## Staff Report & Recommendations

### Riverside Estates Subdivision: Type III

### Preliminary Plat and SEPA DNS

(2017-007-SUB) September 26, 2017

**Figure 2 - Preliminary Plat**

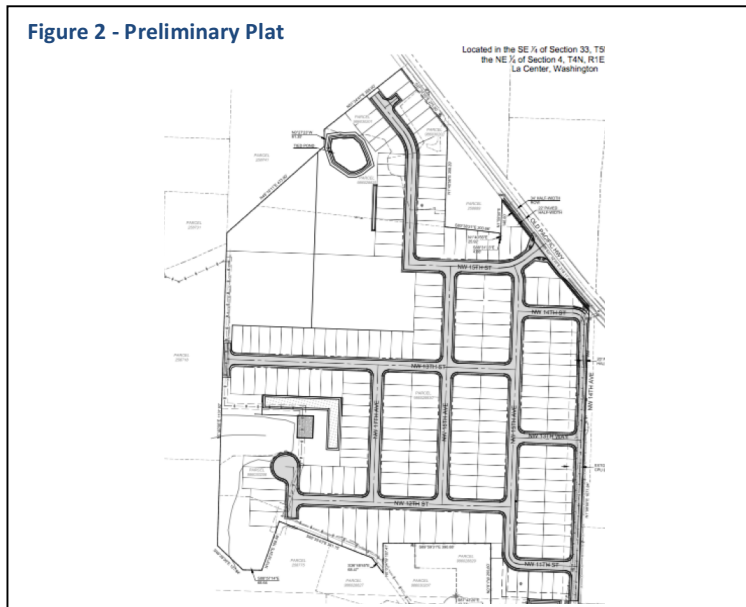
Though the applicant still needs to show the queuing length during peak hour evaluation on a drawing so that the City can be assured that there will be no negative affect to Larsen Drive (NW14th Ave) access once built.

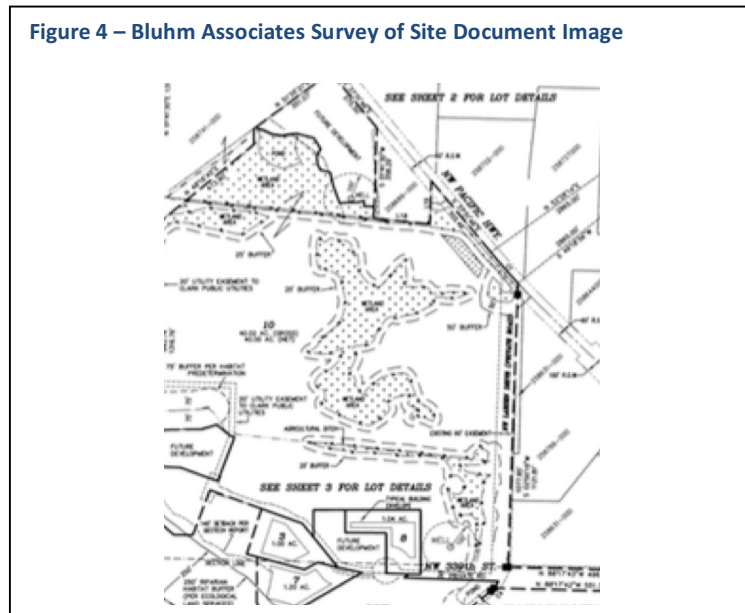
- *The wetlands shown by Bluhm Associates<sup>7</sup> on Parcel 986028830 do not exist;*
- *The proposed 2009 Wetland Mitigation Plan prepared by ELS identifies Parcel 986028830 wetlands as Wetland A (northernmost), Wetland B (southernmost) ...based on the Bluhm and Associates drawings and additionally do not meet current wetland delineation standards.*
